APPLICATION NO.	FILING DATE	FIRST NAMED INVENTOR	ATTORNEY DOCKET NO.	CONFIRMATION NO.
10/534,180	05/05/2005	Bruno Herren	82000.2020	3374
	7590 06/19/2007 AW GROUP PLLC		EXAMINER	
1201 THIRD AVENUE, SUITE 330			FRANCIS, FAYE	
SEATTLE, WA	X 98101		ART UNIT PAPER NUMBER	
			3725	
			MAIL DATE	DELIVERY MODE
			06/19/2007	PAPER

DETAILED ACTION

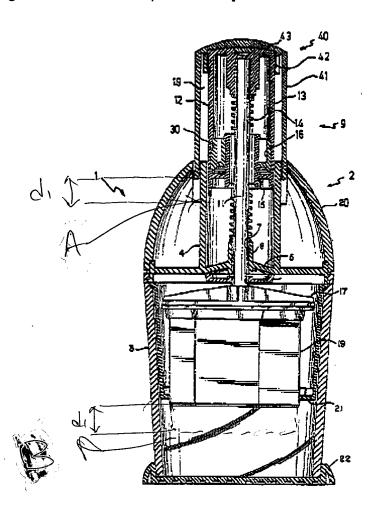
Michel discloses in Fig 1 (also see Figure below wherein the letters A-B and d1 have been added by the examiner), a hand-operated crusher which is capable of cutting

up ice, comprising a housing 1 having an upper part 2 and a lower part 3, a vertical rod [plunger 11], a spring 14, means of an actuating mechanism having a push button 12 and a knife 19 wherein the cutter at is lowermost position, does not contact the base of the housing lower part [as clearly shown in Fig 1, the actuating mechanism can only be lowered a distance d1 to point A, therefor moving the blade downward to point B and leaving a gap between the blade and the base of the housing].
